Evaluation of proposed move for Water Right No. 4378

Proposed: Move water right no. 4378 to a new well location a distance of 2,298 ft to the northeast.

WELL TEST ANALYSIS

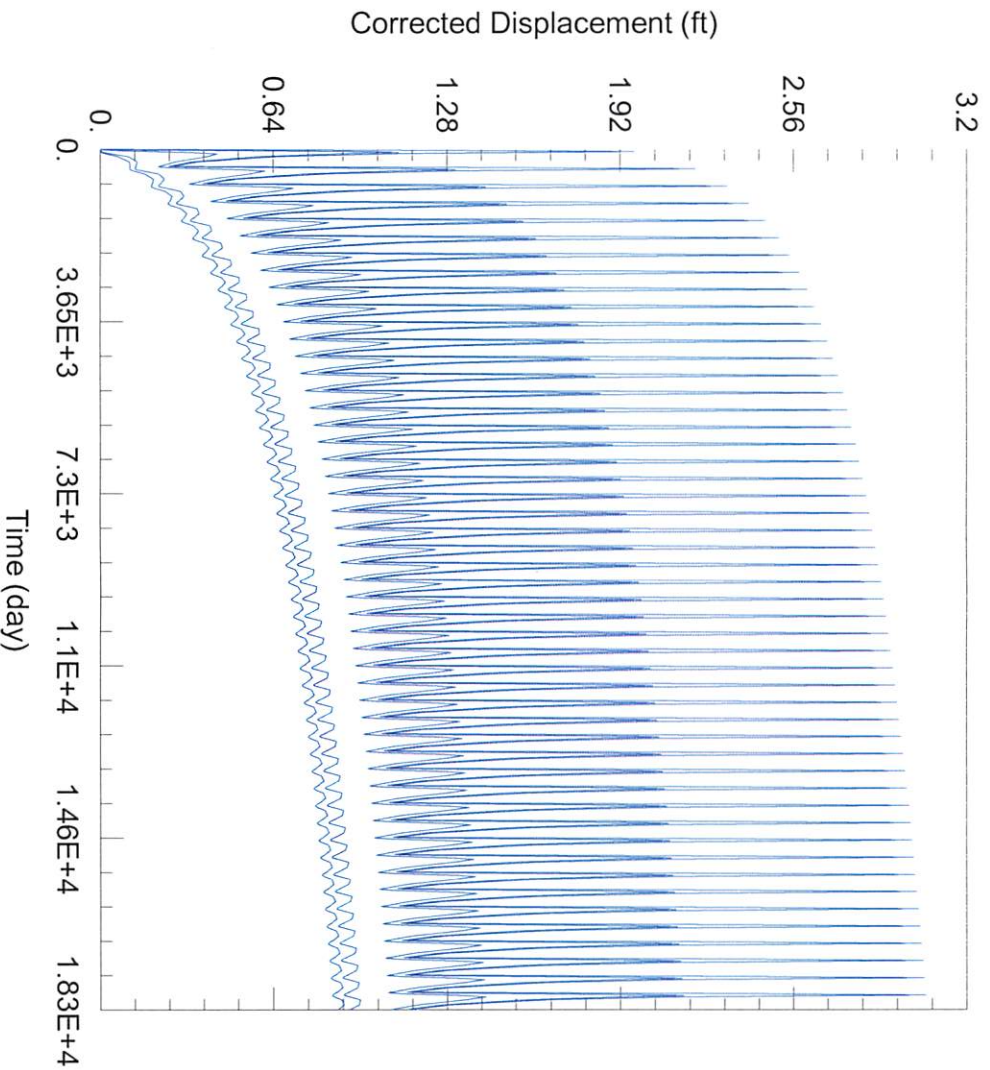
Data Set: C:\Users\trevora\Documents\2021_Moves\4378\4378 Proposed.aqt

Project: 4378

Well Name	X (ft)	Y (ft)
4378	-91495	162791

Well Name	X (ft)	Y (ft)
□	-91495	162791
□ <u>3424 & 6073 & 8059</u>	-93856	162974
□ <u>11070</u>	-93603	160260
□ <u>6073 & 8059</u>	-96249	163015
□ <u>25661</u>	-88563	162872
□ <u>727</u>	-87959	160940
